**NOTIFICATION**

#0008

**RELEASE DATE:** 04/06/2021  
**EFFECTIVE DATE:** 04/06/2021  
**SUBJECT:** Potential risk of trim tab motor disconnecting from elevator skin  
**MODELS AFFECTED:** All Sling aircraft delivered prior to October 2020  
**COMPLIANCE TIME:** During pre-flight inspection

Figure 1: Ensure all four attaching screws are present

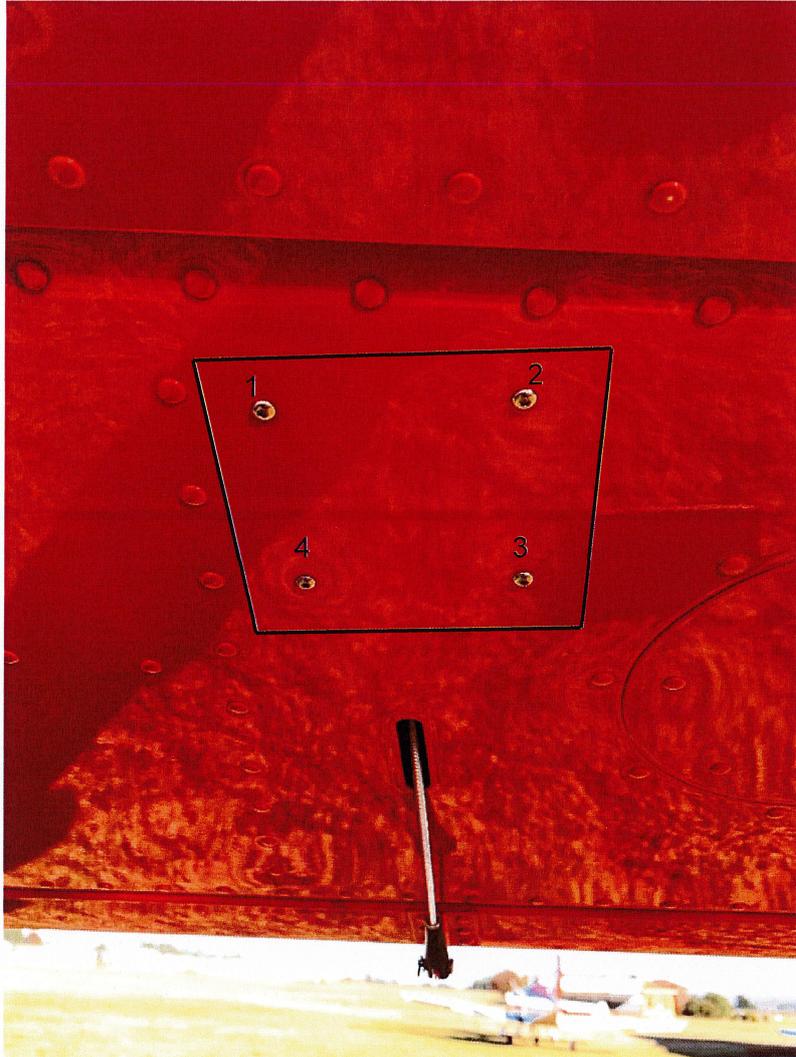
- a) The trim tab motor is secured to the elevator skin with four M3x10mm button head screws. Check that all four screws are present as shown in Figure 1.

- e) For aircraft produced after October 2020, the M3 rivnuts and M3x10mm button head screws have been superseded by 8-32 single lug anchor nuts and 8-32 x 1/2" stainless steel machine screws, respectively, to reduce the risk of trim motor disconnection.

- b) Missing screws must be re-installed with Loctite 222.
- c) In the unlikely event that missing screws result from rivnut failure (such as the rivnuts(s) breaking off from the trim motor flange), rivnuts must be replaced with 8-32 single lug anchor nuts, provided the trim motor flange is absent of damage that would prevent re-use.
